**BOARD OF COUNTY COMMISSIONERS
ORANGE COUNTY, FLORIDA
ADDENDUM NO. 2 / IFB NO. Y15-715-PH**

VISTANA WATER TREATMENT PLANT ROOF REPLACEMENT

TITLE CONDUIT WITH SENSOR COPING PENETRATION DETAIL

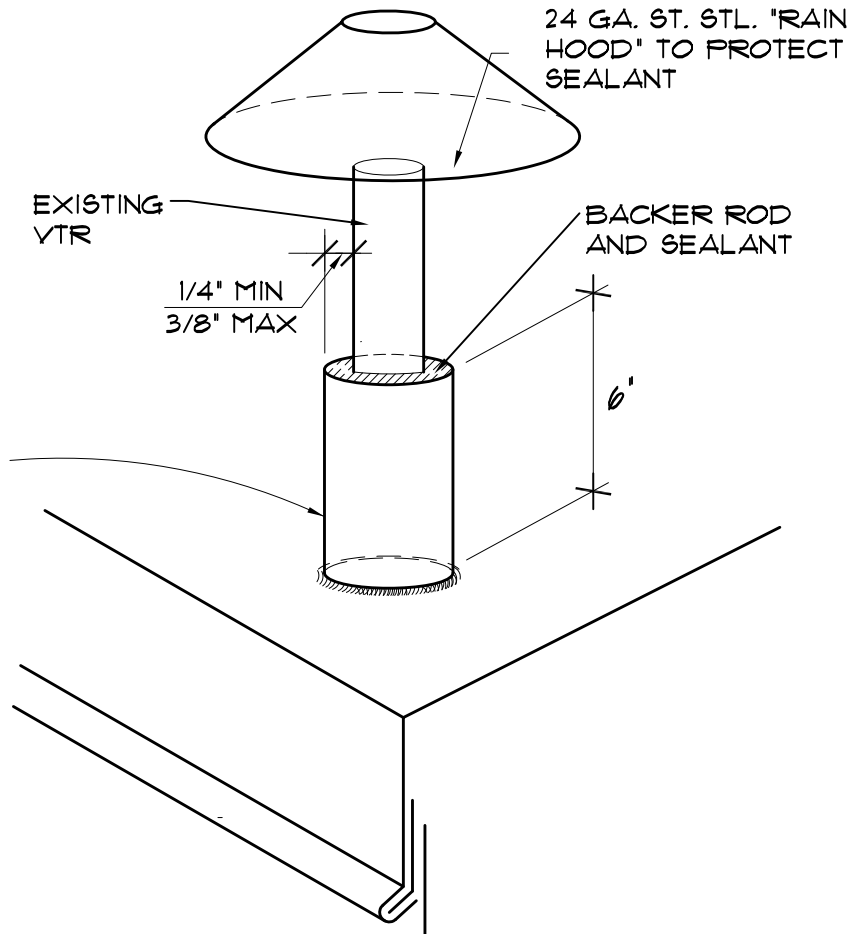
- a. Detail 6.02 – Conduit with Sensor Coping Penetration Detail, Shall be included with the Details.
